- [1] **TYPE OF APPLICATION** - Check Those Which Apply for [A] *NSL = API not yet assigned*
 [A] Location - Spacing Unit - Simultaneous Dedication *Horseshoe Gully #480*
 NSL NSP SD *BIYA Operates*
 Check One Only for [B] or [C]
 [B] Commingling - Storage - Measurement
 DHC CTB PLC PC OLS OLM
 [C] Injection - Disposal - Pressure Increase - Enhanced Oil Recovery
 WFX PMX SWD IPI EOR PPR
 [D] Other: Specify: **AMEND NSL-6320 AND NSP-1948 DUE TO SURVEY INFORMATION**

RE: Request for Amendment to NSL-6320 and NSP-1948

BIYA Operator's: Horseshoe Gallup #400 (proposed new well)
Surface: 1123' FNL & 863' FWL (Lot #1 of D). Sec. 28 T31N R16W, San Juan County, NM
Horseshoe Gallup Pool (32870)

WELL LOCATION AND ACREAGE DEDICATION PLAT

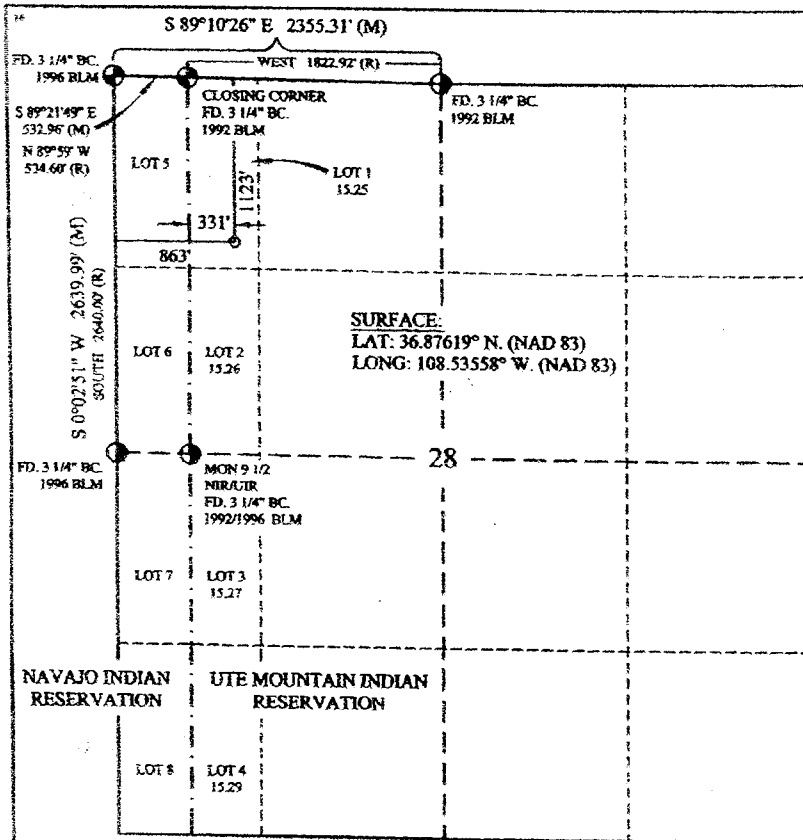
Since the original NSL/NSP application on January 7, 2011, there have been several changes that should be amended on orders NSL-6320 and NSP-1948. The actual well's staked location has not changed, but a subsequent field survey indicated errors in the original survey. The attached C-102 both corrects the survey errors and clarifies the well's location and acreage.

1. The well name and number are now: **HORSESHOE GALLUP #400**
2. The footage from the north line is corrected to be 1123' FNL.
3. The footage from the Mt Ute reservation line is still 331'.
4. The footage from the west section line is clarified to be 863' FWL.
5. The elevation is corrected to 5644'.
6. The acreage of Lot #1 is clarified to be 15.25 acres. (This was correct on the application C-102, but incorrect in its attached letter).
